**RESOLUTION NO. 2019-035**

**A RESOLUTION OF THE CITY COUNCIL OF THE CITY OF ELK GROVE  
CERTIFYING THE ENVIRONMENTAL IMPACT REPORT FOR THE GENERAL PLAN  
AND ADOPTING FINDINGS OF FACT AND STATEMENT OF OVERRIDING  
CONSIDERATIONS AND A MITIGATION MONITORING AND REPORTING  
PROGRAM**

**CITY OF ELK GROVE  
GENERAL PLAN UPDATE  
FINAL ENVIRONMENTAL IMPACT REPORT**

### 4.3 RESPONSES TO COMMENT LETTERS

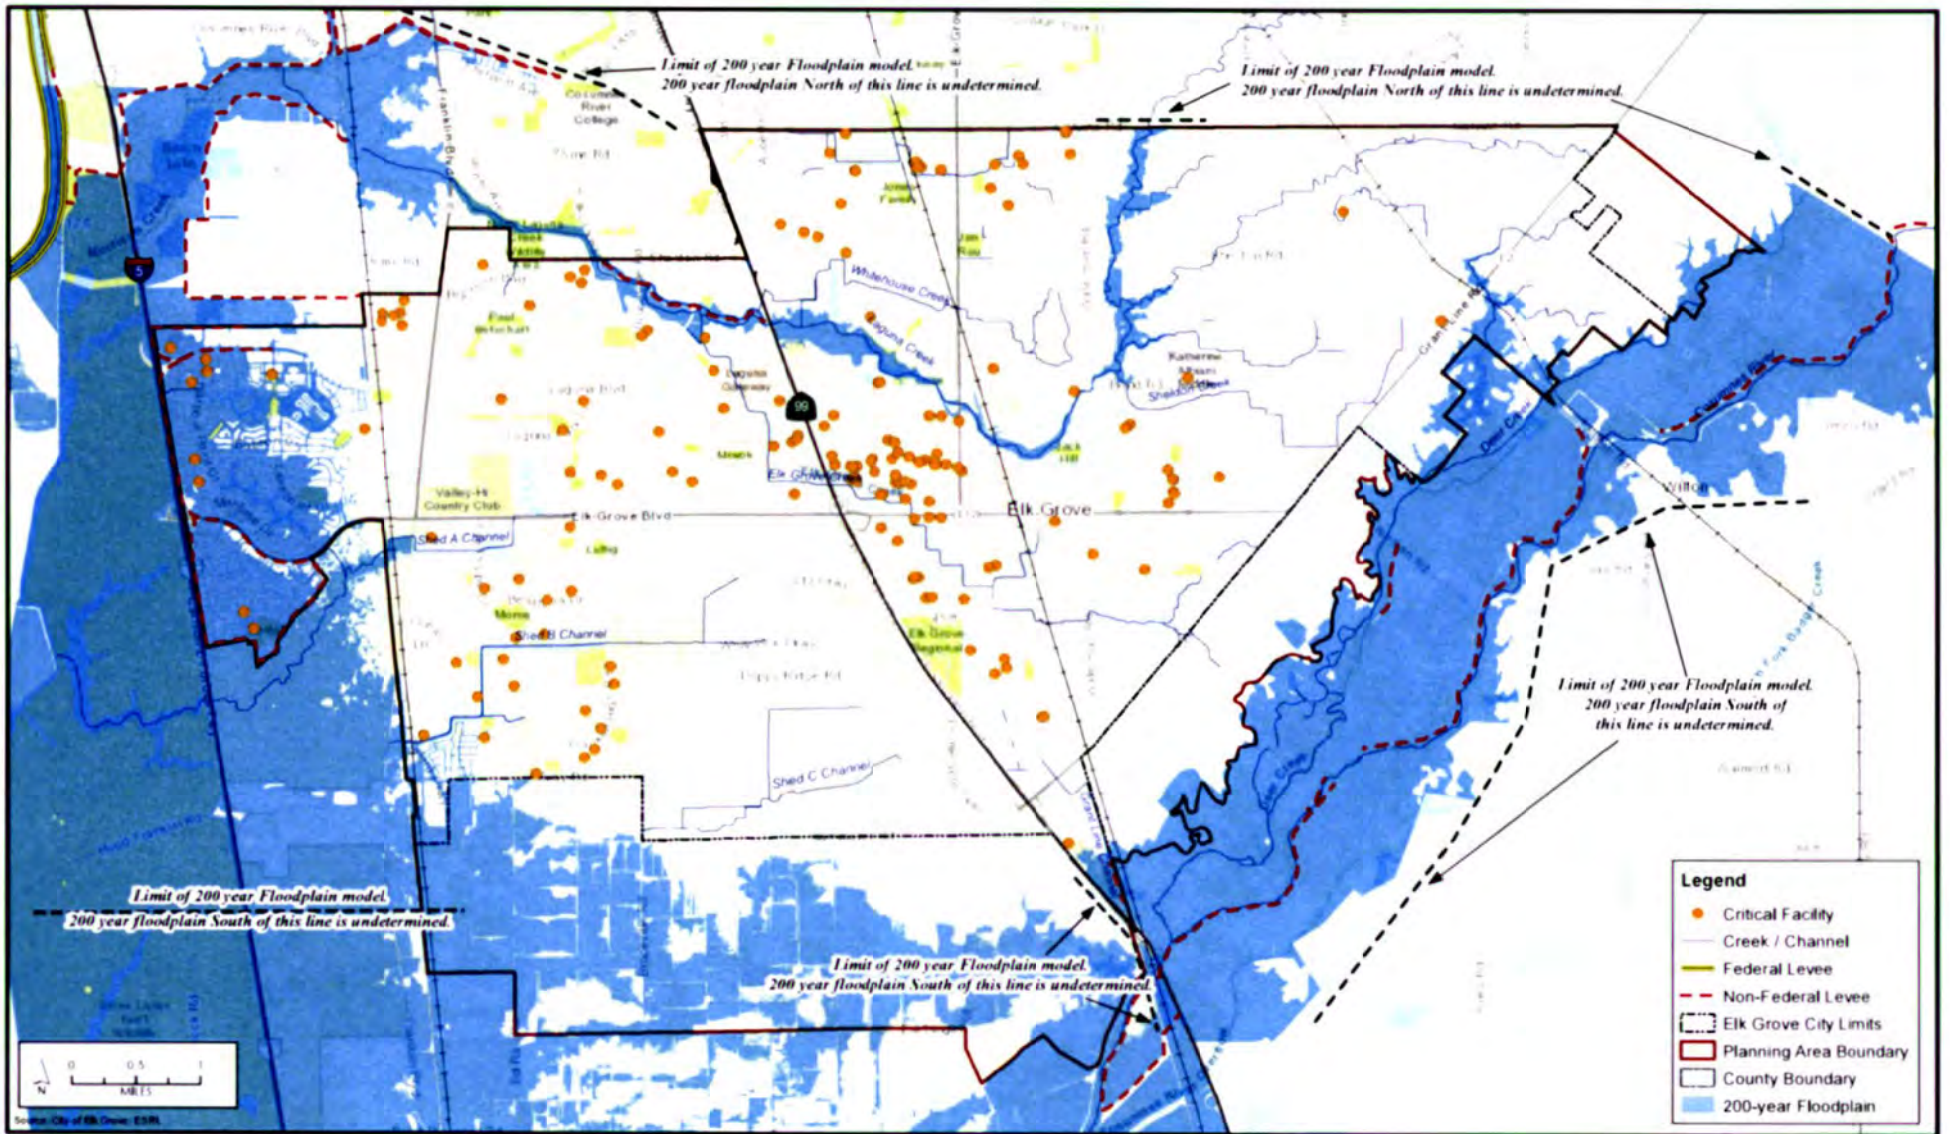
**Figure 5.9-3, 200-Year Floodplain**, has been updated as shown at the end of this chapter.

Current Crane Habitat Value (Not Accounting for current abundance patterns)

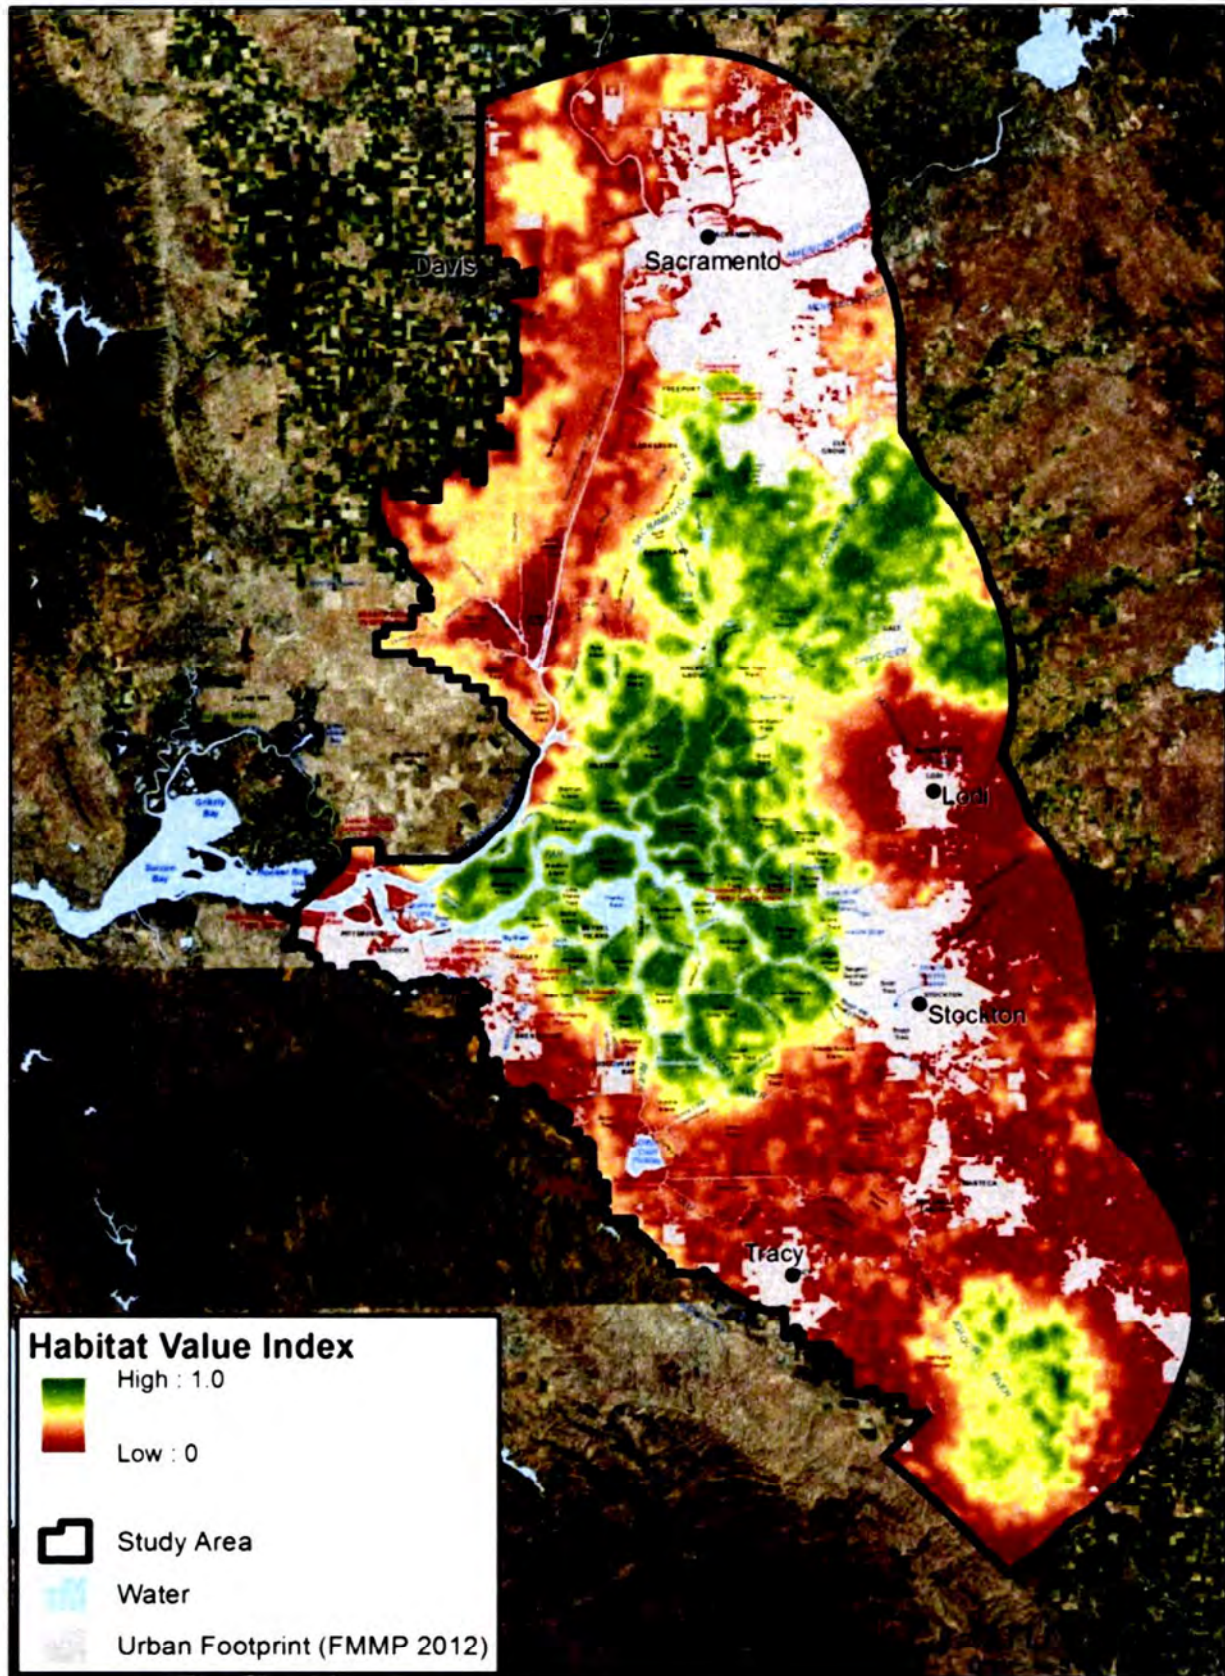
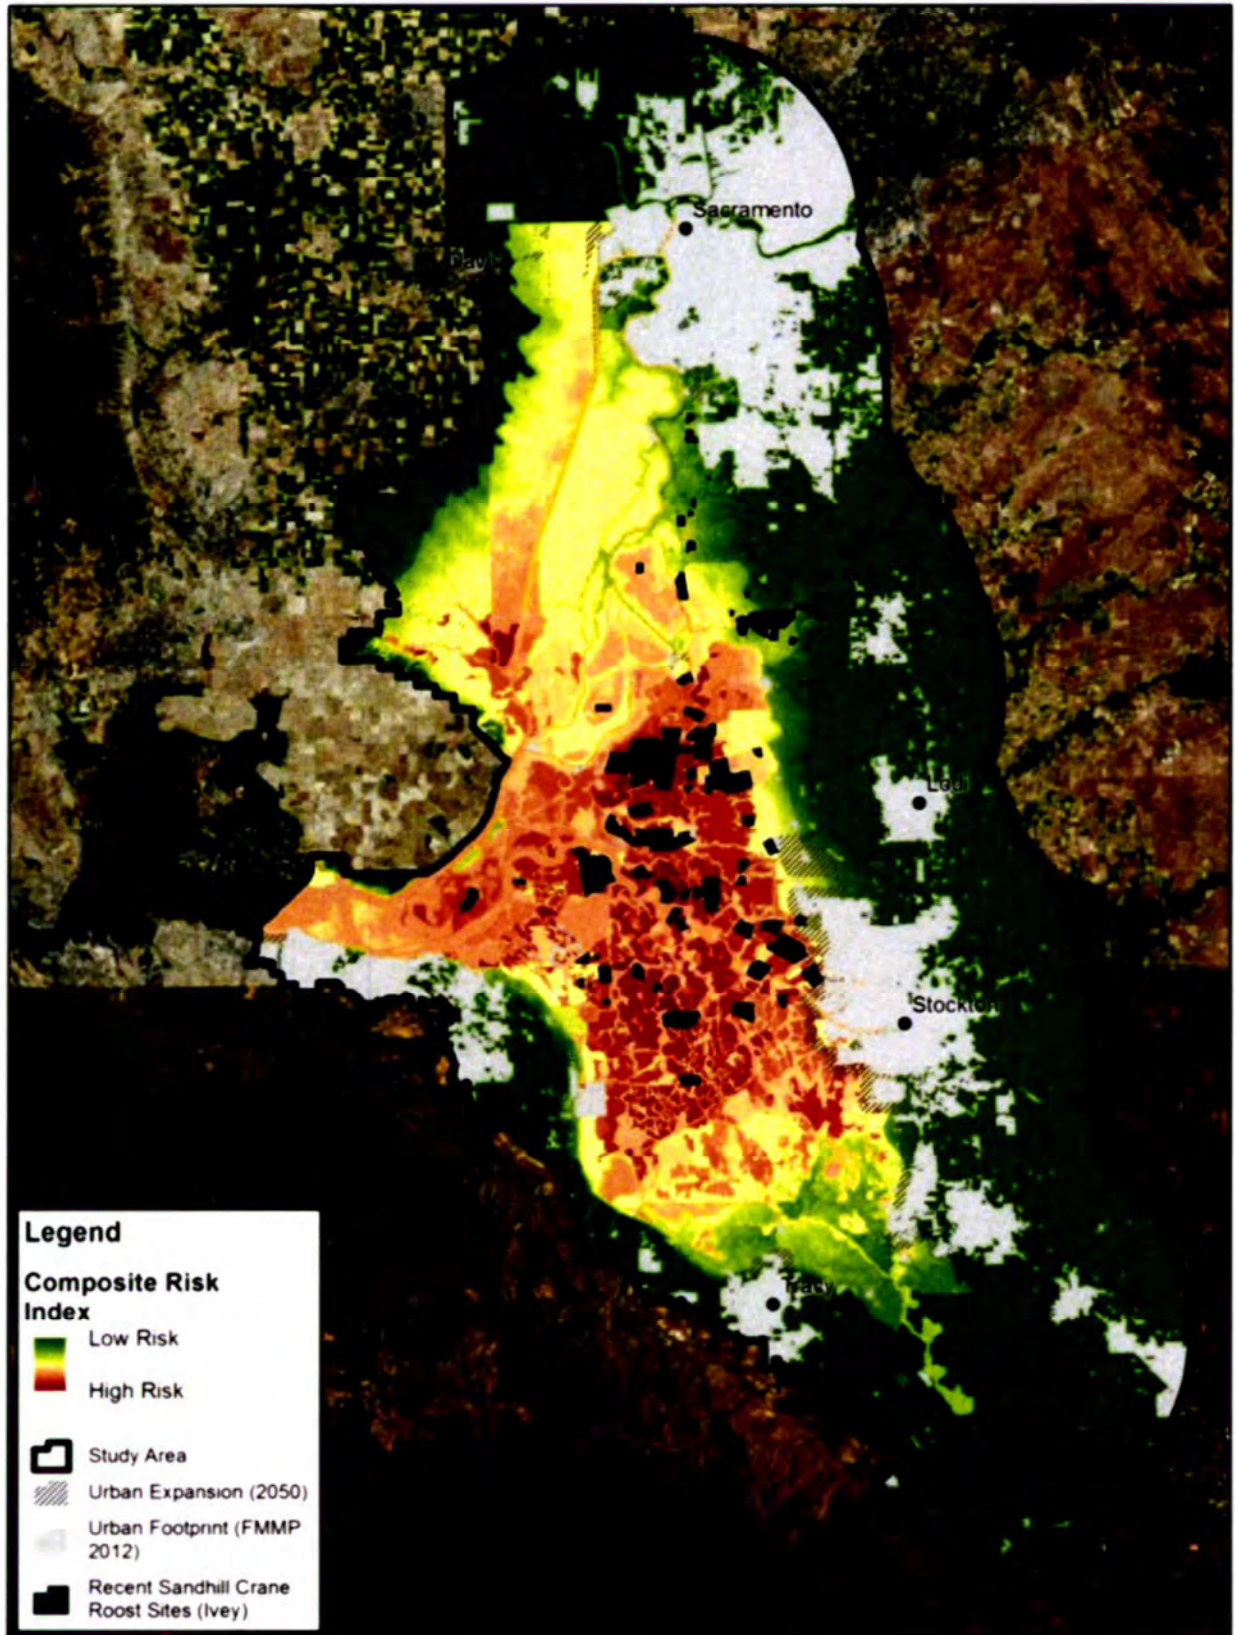
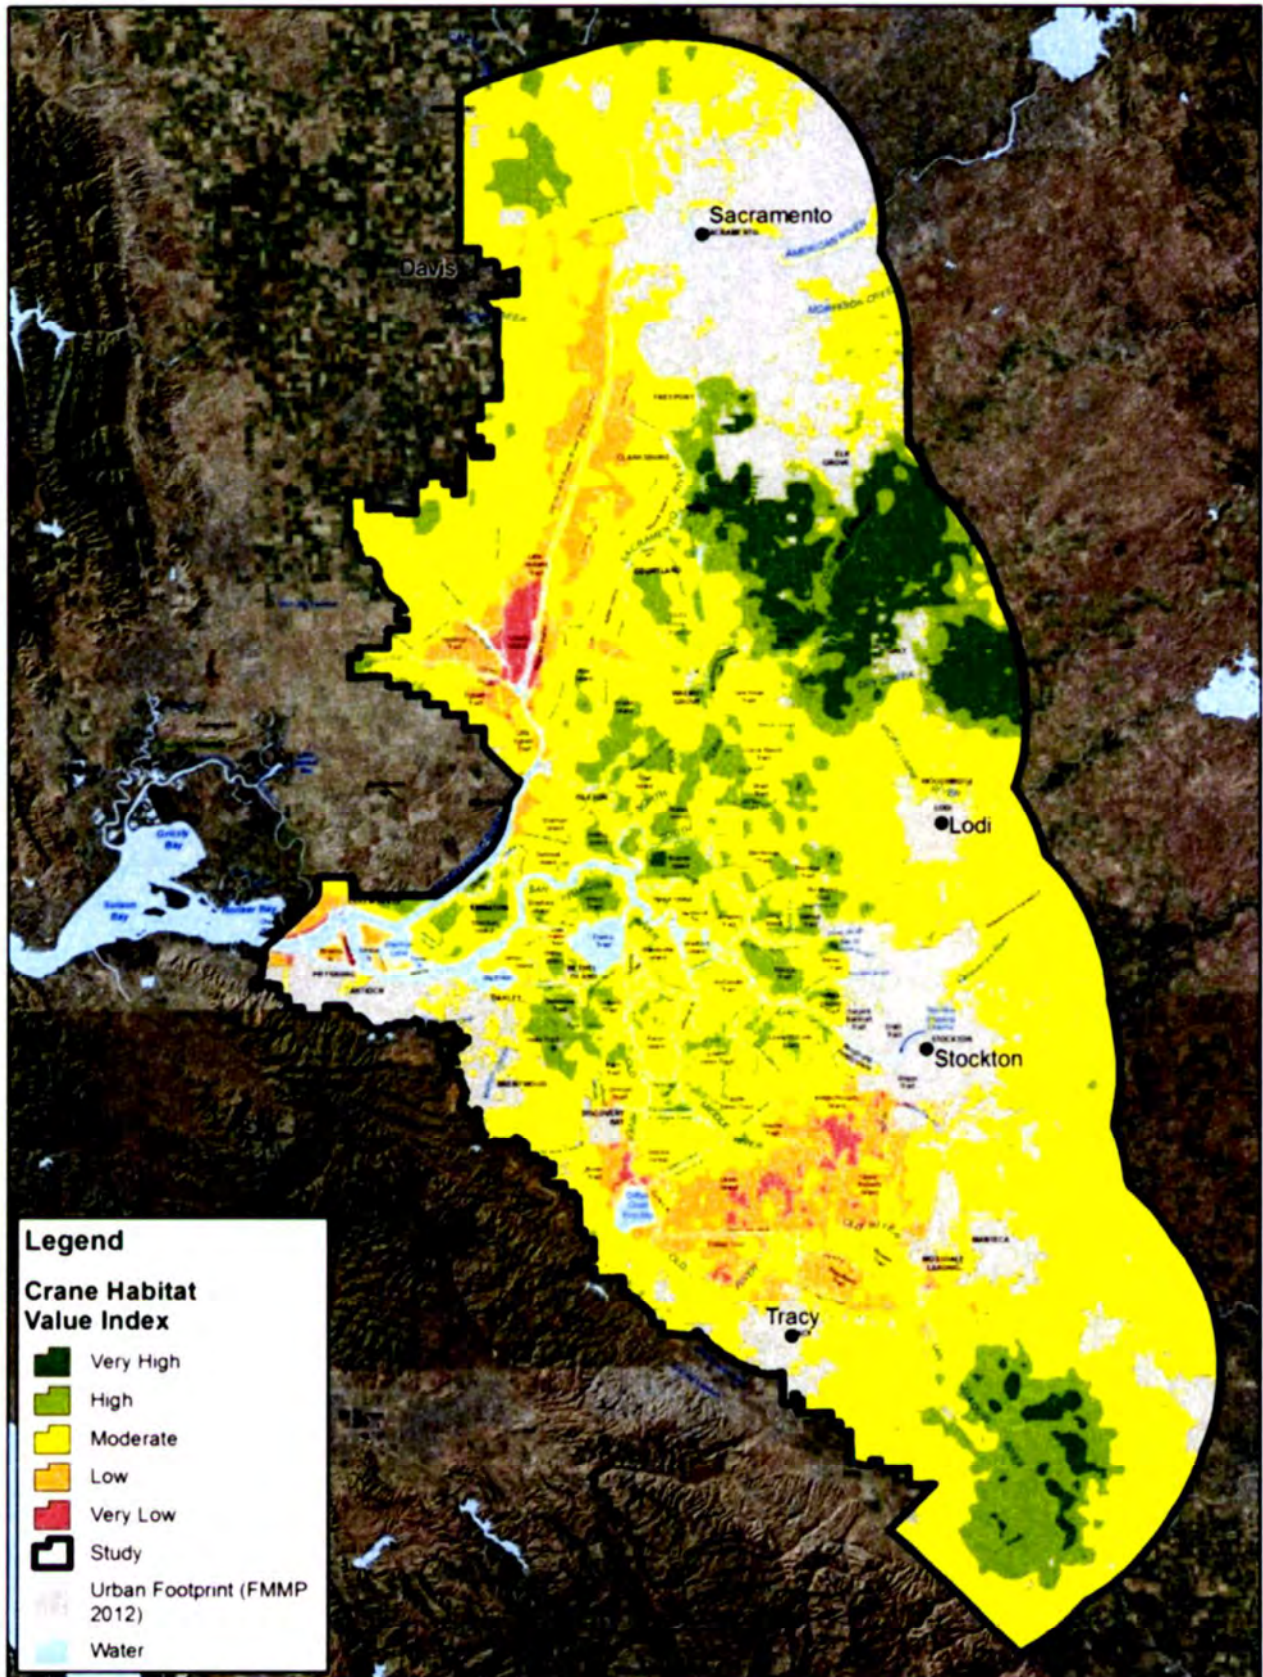
The first map (figure 1) depicts current high value crane habitat based on suitable ground cover-type and distance from established roost sites (within a 2-mile diameter of established site). This draft map has yet to be adjusted for relative abundance of cranes, which would increase the priority of available habitat close to roost sites with greater numbers of cranes. The second map (figure 2) depicts the areas that are at risk of permanent inundation based on conservative sea level rise predictions, relative existing elevations, and potential for levee failure. Virtually all of the lands currently conserved for Greater Sandhill Cranes are at risk of being lost. This realization has resulted in the need to rethink long term conservation strategies for sandhill cranes in the Delta and its surrounding landscapes, not to mention all of the other listed and special concern species that share the same landscapes. The third map (figure 3) attempts to depict how conservation priorities need to shift to address the threat of sea level rise. It attempts to balance the importance of habitat near historic roost sites with the need to shift populations to the east where there is higher elevation and thus more sustainable long-term habitats.

The commenter discusses Dr. Rod Kelsey's preliminary modeling in the north Delta to identify targets for greater sandhill crane conservation. The modeling effort was presenting on three maps included with the comment letter. The first map (figure 1) depicts current high value crane habitat based on suitable ground cover-type and distance from established roost sites (within a 2-mile diameter of established site). The second map (figure 2) depicts the areas that are at risk of permanent inundation based on conservative sea level rise predictions, relative existing elevations, and potential for levee failure and illustrates most conserved lands are at risk of being lost. The third map depicts how conservation priorities need to shift populations to the east.

The commenter states the West and South Study Areas fall squarely within the highest-priority long-term areas for conservation. It is difficult to discern the location of the West and South study areas in figures 1-3. However, Figure 5.9-3 of Section 5.9 Hydrology and Water Quality indicates that most of the West and South Study Areas are inundated in a 200-year event (assuming extensive levee failure especially along the north bank of the Cosumnes River). This analysis illustrates that these Study Areas do not present long-term foraging opportunities during levee breaks. As such, the analysis requested by the commenter is not required. See Response 3-7 regarding the need for additional study and CEQA requirements.
